The **City of Stoughton** will hold a joint meeting of the **Planning Commission and Business Park North Committee** on **Monday, June 13, 2011 at 5:30 pm**, in the **Council Chambers**, Second Floor, **Public Safety Building**, 321 S. Fourth Street, Stoughton WI.

**RE: Proposed Pharmacy Audit Assistance Services**

I have completed a review of the proposed new building at Park Place, 160 Business Park Circle - Plan submitted 6/7/11. As noted, additional information may be required to be provided or shown on the plan.

**1 SITE PLAN**  
C-11 SCALE: 1" = 20'-0"

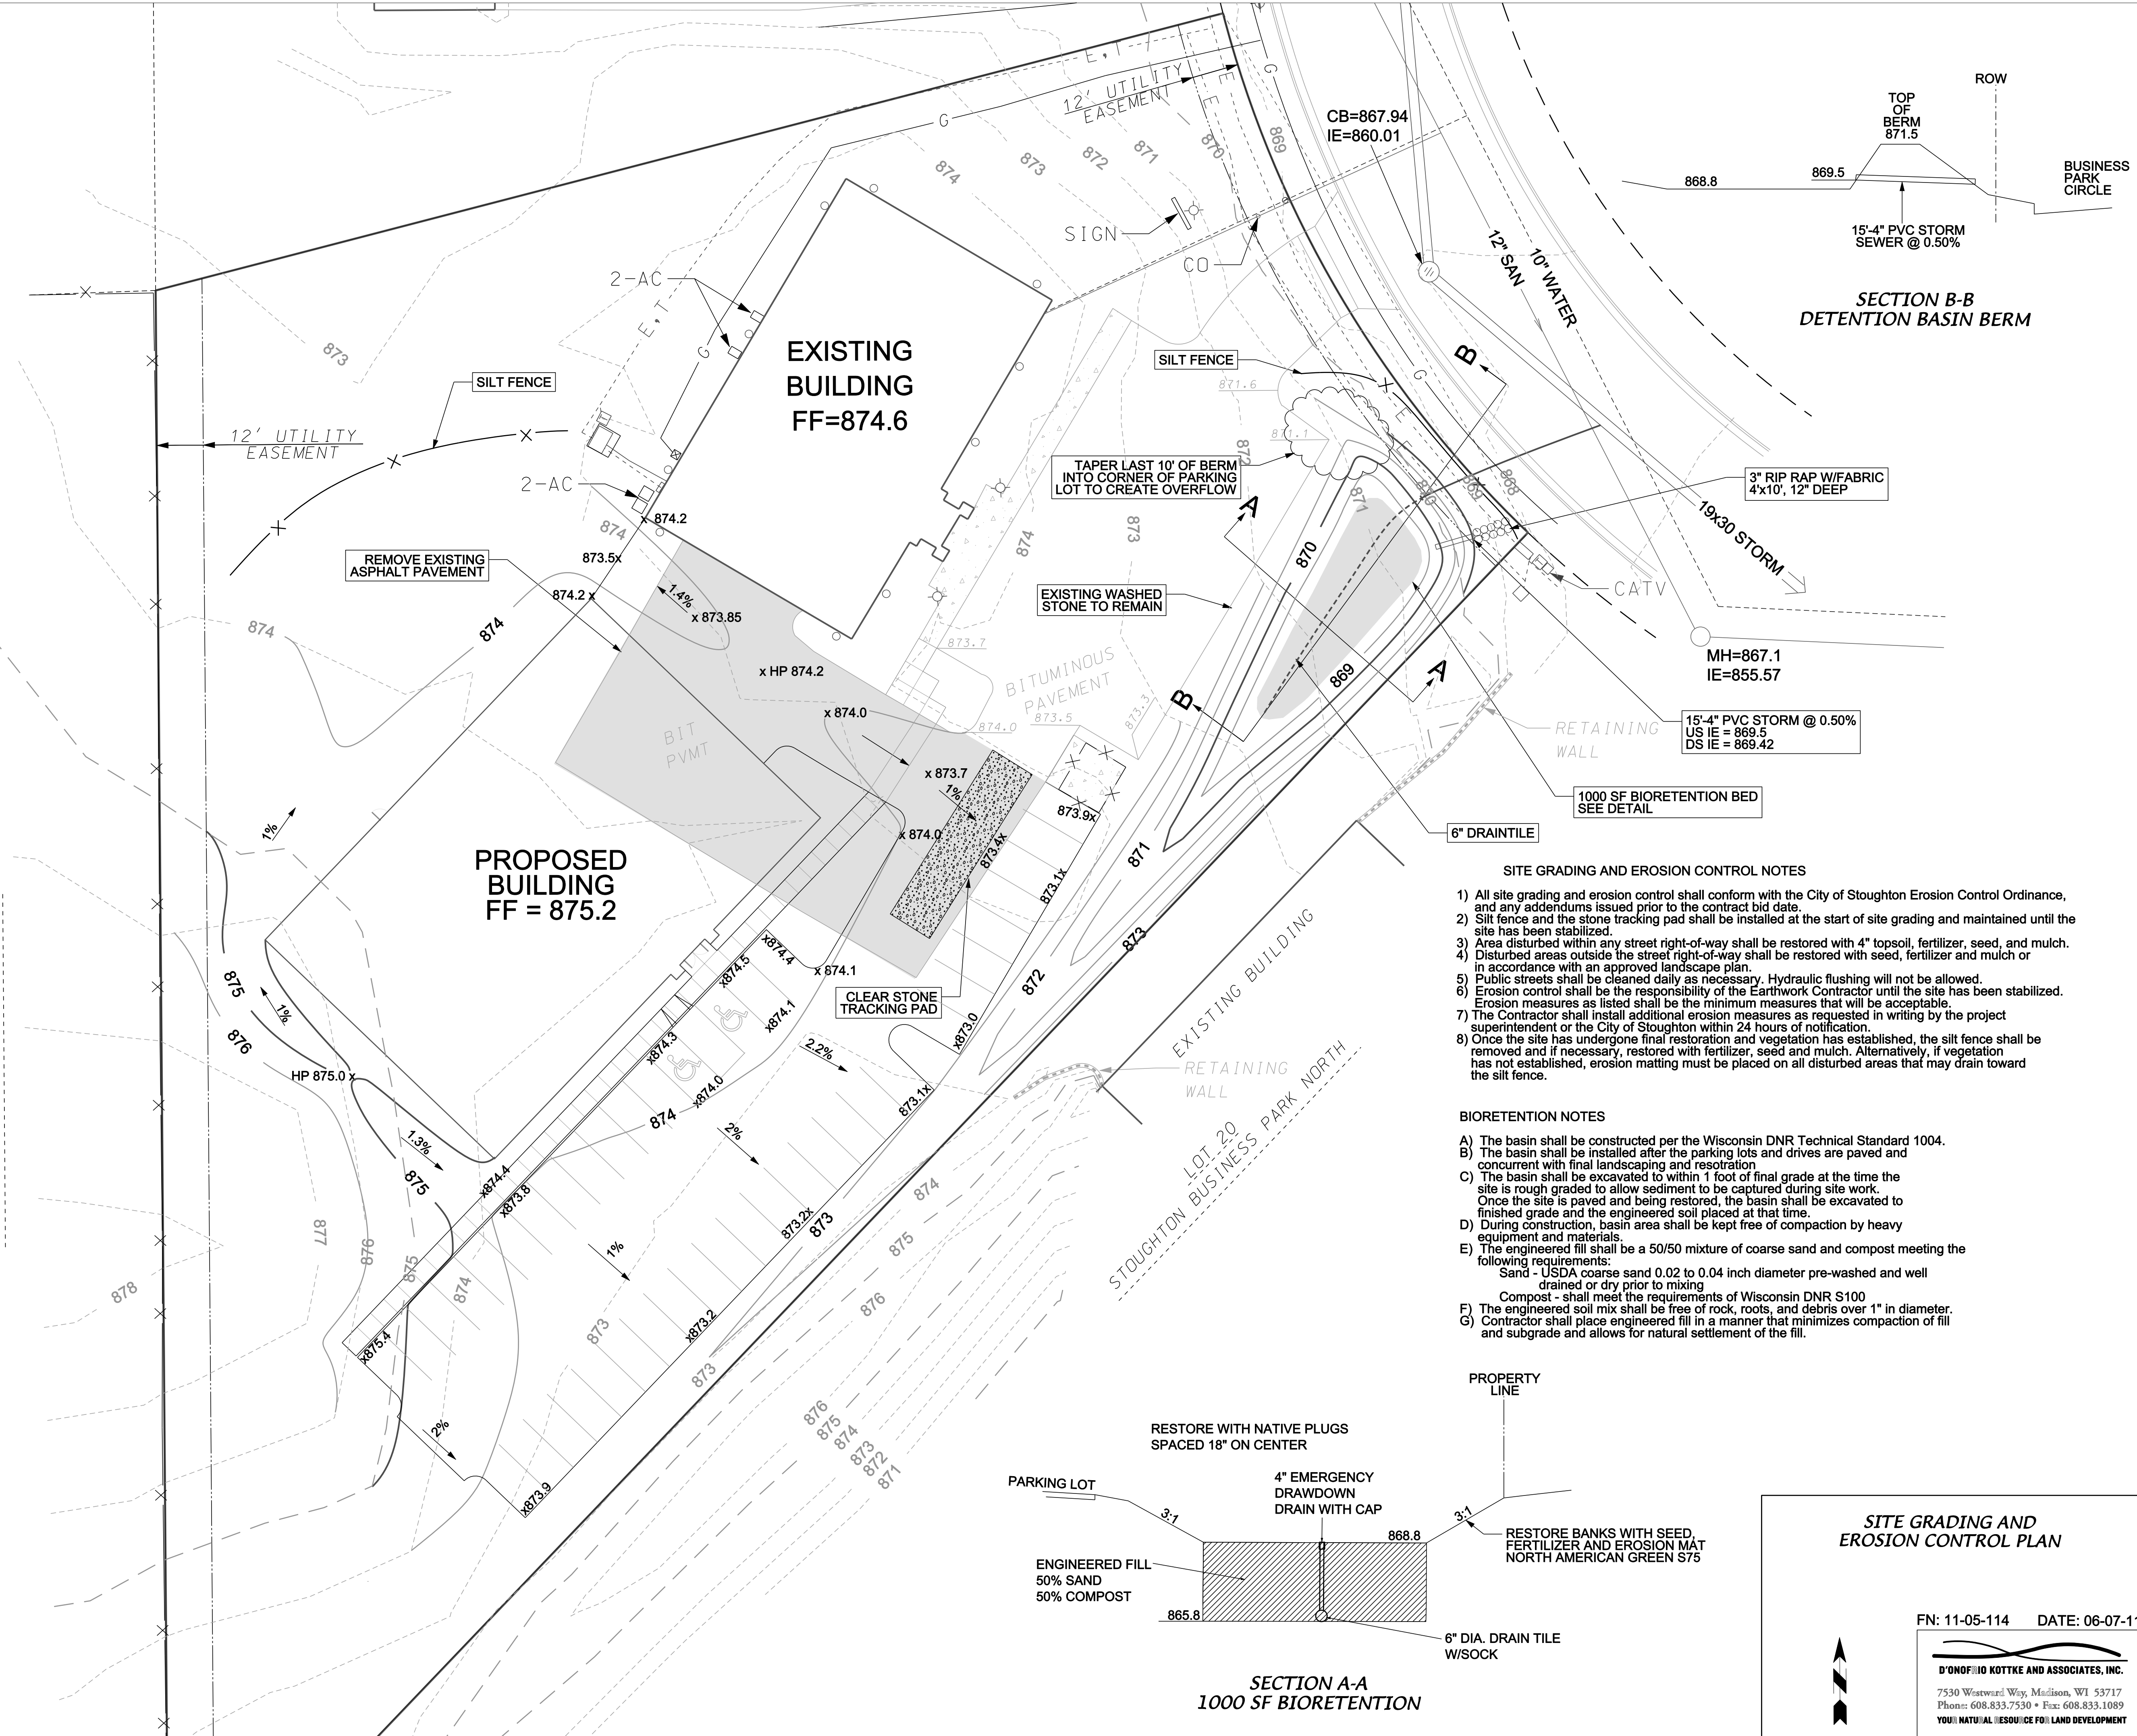
3. The parking requirement for an office land use is one space per 300 square feet of gross floor area. There are 62 parking spaces proposed to accommodate both buildings. Code requires 54 parking stalls total. No site plan may be approved which contains more than 120 percent of the required minimum number of parking spaces. **The proposed parking complies with these requirements.**

6. Per section 78-704 (13)(a), bicycle parking is required equal to 10% of the automobile parking space requirement. **There are specific requirements related to bicycle parking in section 78-704 (13)(c). This requirement pertains to any new parking. Four bicycle parking spaces are require and are provided on the plan.**

7. One off-street loading stall requirements per section 78-705. **If deliveries or shipments are anticipated an off-street loading stall will need to be provided. Trucks may not back into the street.**

14. Proposed utilities-including electrical transformers and HVAC locations shall be shown on the plan. **The utilities are delineated on the plan. HVAC locations for the new building shall be delineated on the plan. A street opening permit will be necessary for work in the street right-of-way.**

- f. Site statistics, including site square footage, percent of site coverage’s and percent of park or open space. **This is provided on site plan.**

**SITE GRADING AND  
EROSION CONTROL PLAN**

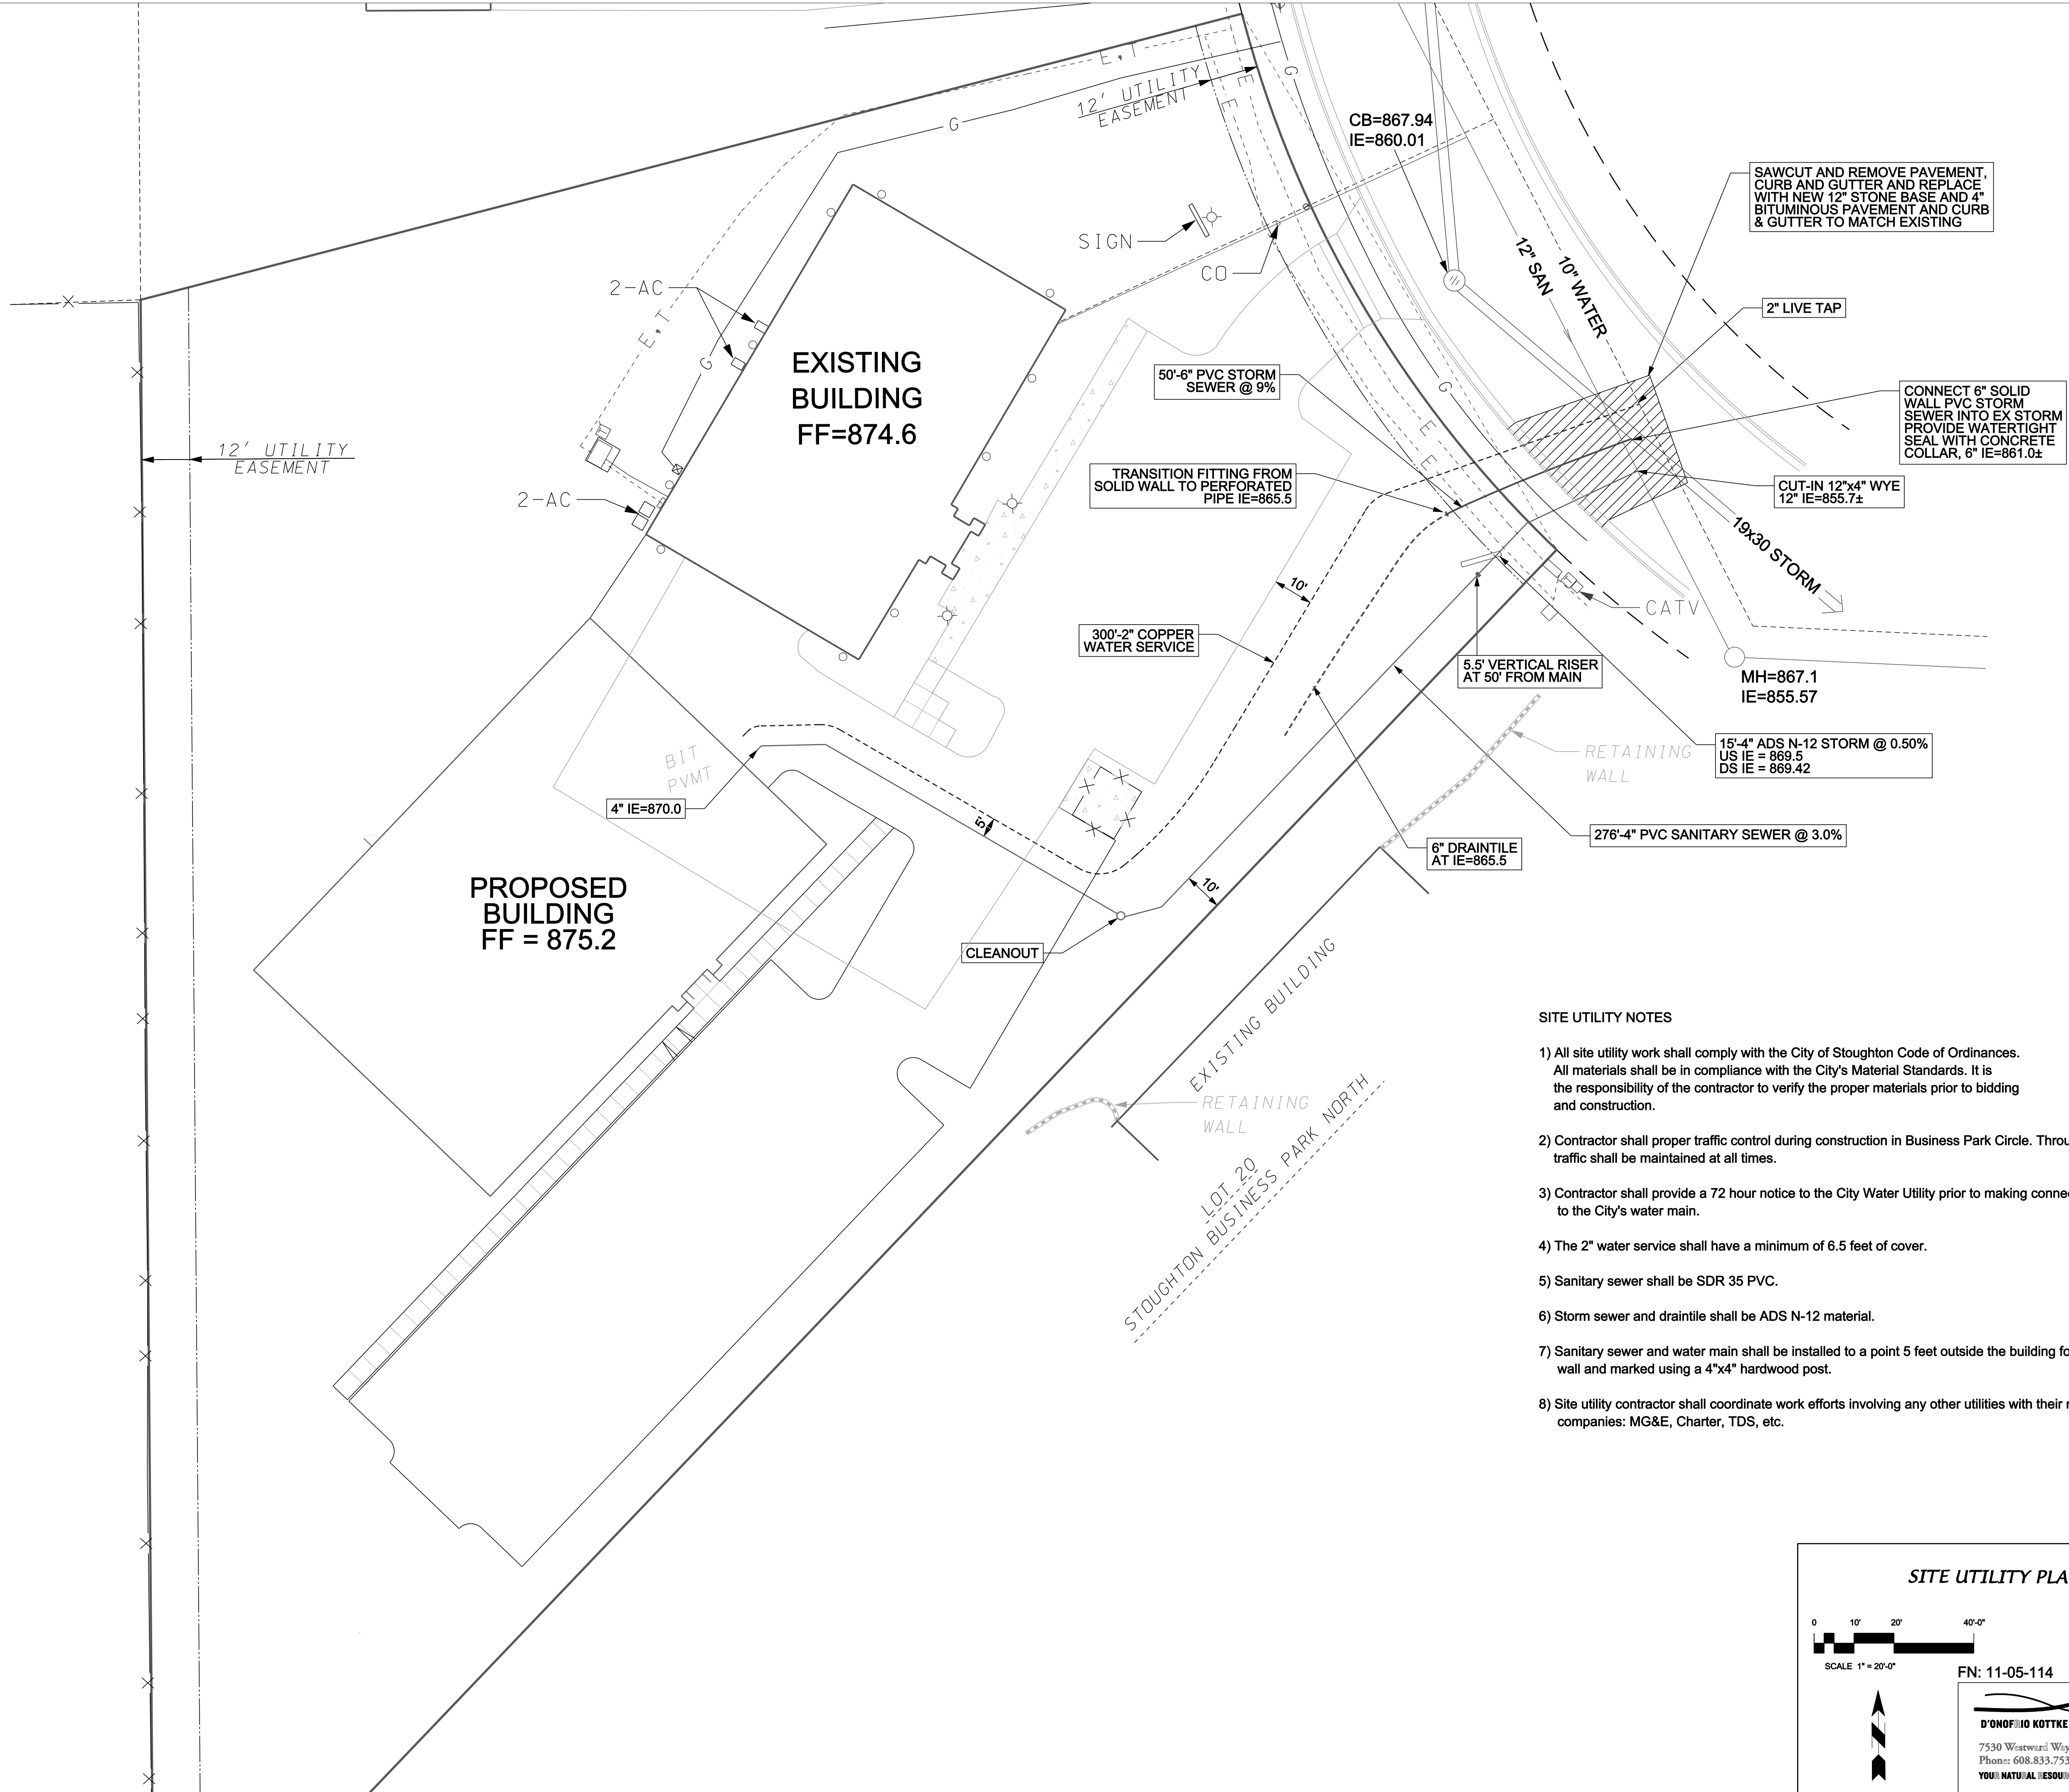
12. **There is an existing trash enclosure for the handling of waste.**
13. A stormwater management and erosion control plan, application and fee are required. Dane County Land Conservation, the City’s consultant, will review the plan and perform inspections. **The plan, application and fee shall be submitted to the Department of Planning & Development office at City Hall. This has been submitted.**

- e. Clearing, grading, and drainage plan showing proposed clearing limits, existing and proposed contours at two foot intervals. **The provided grading plan with one foot contours is sufficient to meet this requirement.**
